March 22, 2001

Subject: Grand Gulf Nuclear Station
Unit 1
Docket No. 50-416
License No. NPF-29
Response to NRC Request for Additional Information
Regarding Cycle 12 Reload Proposed Amendment,
LDC-2000-076

Response to Request for Additional Information

Figure 1.2 : EOC Radial Power Histrogram

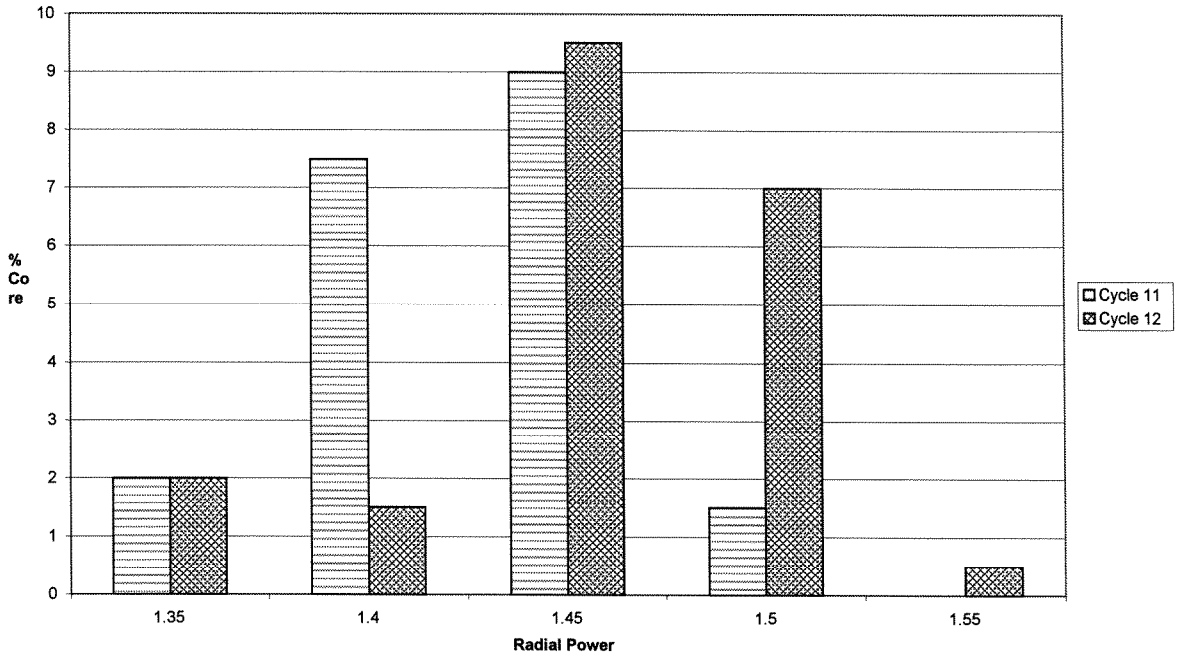
Provide the fuel types and numbers of assemblies used in Grand Gulf Nuclear Station, Unit 1 (GGNS), Cycle 12 operation and identify if they are fresh or irradiated fuel (once or twice burned, etc.) Also, provide the fuel loading pattern for Cycle 12 operation, identify its difference from Cycle 11, and the impact on the SLMCPR calculation.

The full core loading map is provided in Figure 1.1. While we do not expect this information to change, any final core design changes will be evaluated to confirm that the proposed Technical Specification changes remain valid.

The cycle 12 loading plan is very similar to the cycle 11 core loading. Both cycles use a conventional core loading in which fresh and irradiated fuel bundles are distributed in a checker board configuration throughout the interior region of the core with more depleted fuel loaded on the core periphery. The specific loading pattern is selected to meet fuel design limits while maximizing cycle energy. The potential fuel loading impact on the MCPR safety limit is illustrated by Figure 1.2 which shows the high power portion of the end-of-cycle power histograms. The Cycle 12 histogram is shifted to slightly higher powers due to the improved thermal performance of the Atrium 10 fuel but the shapes are very similar. Since the safety limit is more sensitive to the shape of the histogram, this indicates the core loading changes have little impact on the difference between the Cycle 11 and 12 MCPR safety limits. The difference is attributed primarily to the differences in methodology between the two analyses. With additional reload batches of Atrium 10 fuel, the radial power distribution is projected to flatten so the proposed safety limit includes margin to accommodate the anticipated impact of these changes.
